# GRISSOM ROAD BUSINESS PARK MASTER DEVELOPMENT PLAN

GRISSOM ROAD BUSINESS PARK  
MASTER DEVELOPMENT PLAN  
PLAN # 006-07

Re: Grissom Road Business Park

**MDP # 006-07**

SHEET NO.  
MDP

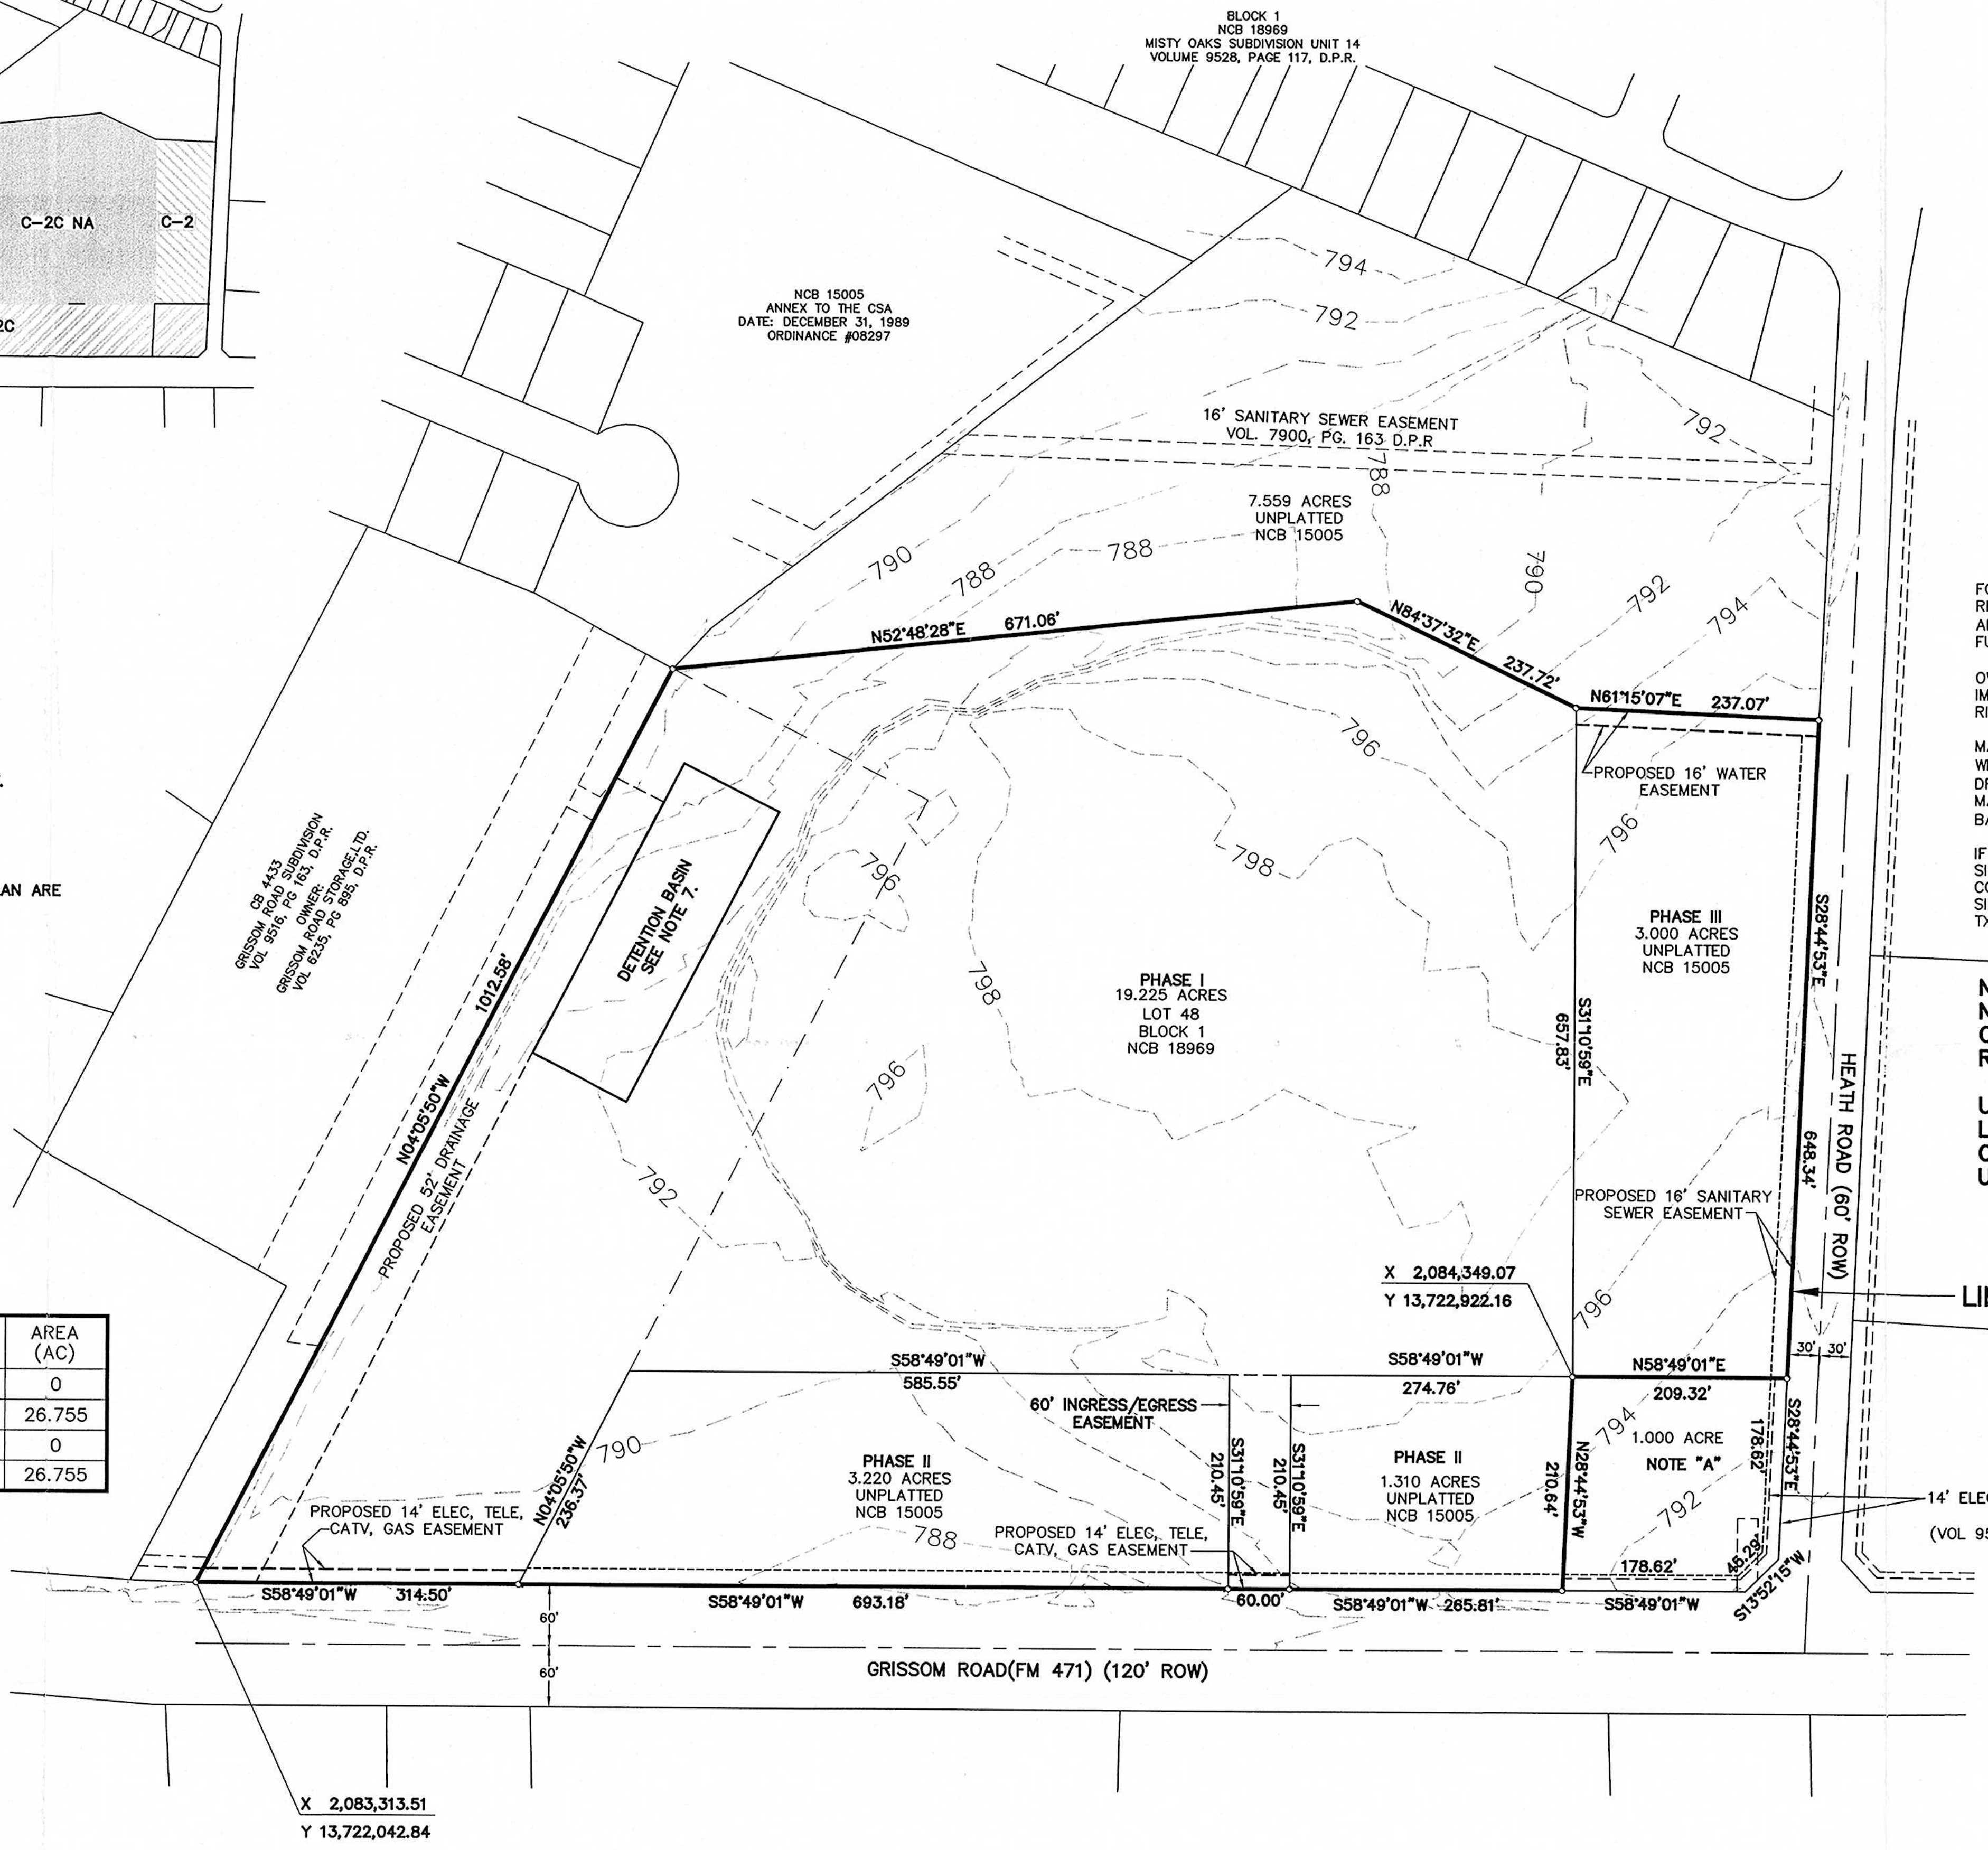
In consideration of public safety and convenience, excessive grades by reason of topography should be avoided in street layouts and arrangements. Any access and R.O.W. issues along state facilities will need to be resolved with the **Texas Department of Transportation (TXDOT)**. For information about these requirements you can contact TXDOT at 615-5814.

- All access driveways shall comply with UDC 35-506(r)
- All roadways shall conform to Table 506-2 Functional Classification System Description for Traditional Design Classification.
- All sidewalks shall comply with UDC 35-506 (q).
- All access roadways shall provide clear sight distance on all existing and proposed roadways in order to provide adequate obstruction free viewing distances for approaching traffic. All signage, landscaping, and improvements shall be selected and located so as to not block these clear sight distances areas.

- 2003 Tree Preservation ordinance standards per UDC Section 35-523 – a Tree Preservation Plan has been approved under for this project – AP 1148085.
- Landscape ordinance per UDC Section 35-511. Some landscape points might be met by preserving existing vegetation (either through preservation of smaller material or transplanting). Recommend securing knowledgeable Landscape Architect at planning and design phase to better utilize existing trees and vegetation. Preservation will eliminate the need for irrigation. Staff would be willing to meet with developer at design stage to assist with tree preservation and landscape plan.

- A soil assessment shall be submitted to the Texas Commission on Environmental Quality before any permits for development of the site in accordance with rule §330.953 of the Texas Administrative Code to determine if the site is a former landfill.
